The proposed zoning district has a setback measured from an existing or proposed future curbline. The location of the future curbline is still an outstanding issue for CDOT.

Resolved Issues

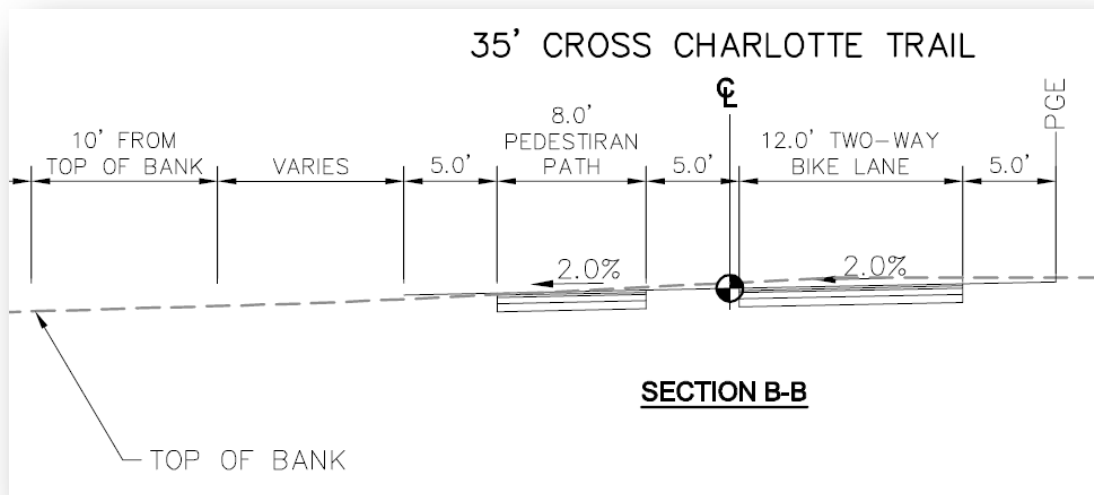
1. CDOT requests that the petitioner clarify their intent for the use of existing unused right of way (see below). The site plan proposes this right of way for site access. If that is the case what are the improvement plans for this right of way? In addition, how will it function with Philemon Ave., Craighead Rd., and the Cross Charlotte Trail?

Cross Section

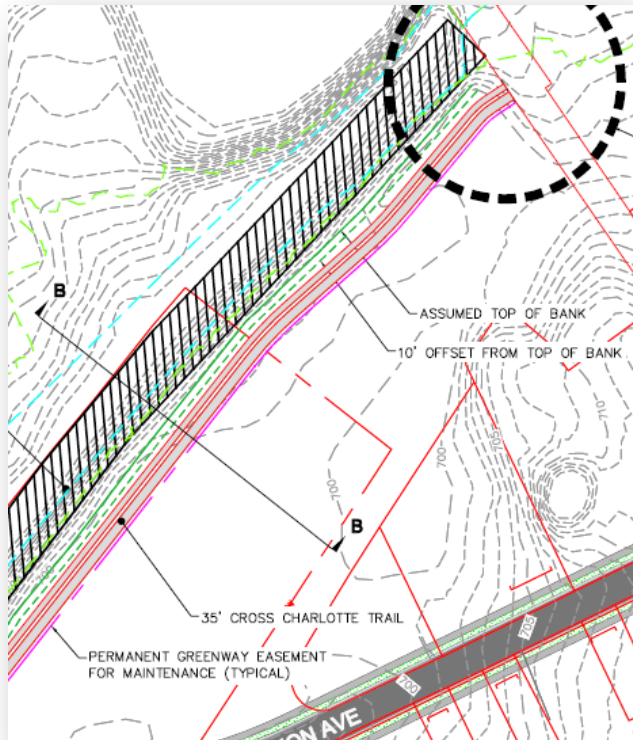
3. CDOT recommends that the petitioner construct the Cross Charlotte Trail per the cross section and along the alignment shown below, including a permanent 35' easement be dedicated for future maintenance of this trail.
